Re: Draft SRS Pit Production EIS – on Proposed SRS Plutonium Bomb Plant (PBP)

Comments on DOE’s National Nuclear Security Administration’s *Draft Environmental Impact Statement on Plutonium Pit Production at Savannah River Site; Aiken, South Carolina*

By Tom Clements, Director, Savannah River Site Watch, Columbia, SC, <https://srswatch.org/>

Figure S-7 Disposition Paths for Surplus Plutonium

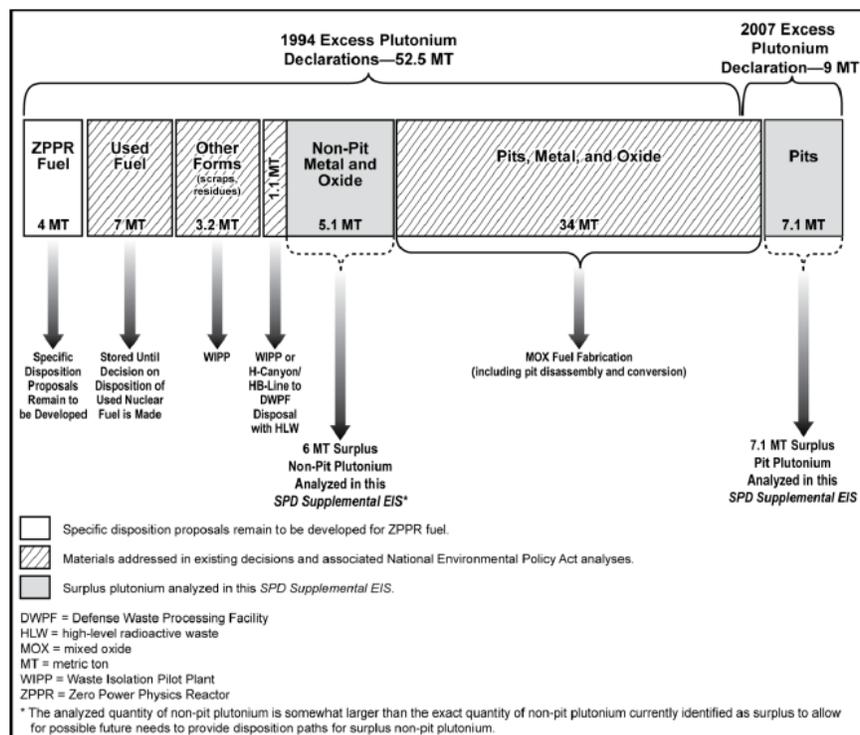
The document is lacking a full explanation of the flow chart for amounts of plutonium coming in for pit production at SRS, and leaving as pits or waste. A full accounting of plutonium sources and amounts (and associated waste streams), such as this chart in the *Final Surplus Plutonium Disposition Supplemental Environmental Impact Statement (SPD Supplemental EIS)* (DOE/EIS-0283-S2), April 2015, page S-9 (https://www.srs.gov/general/pubs/envbul/documents/EIS-0283-S2_SPD_Summary.pdf) is needed:
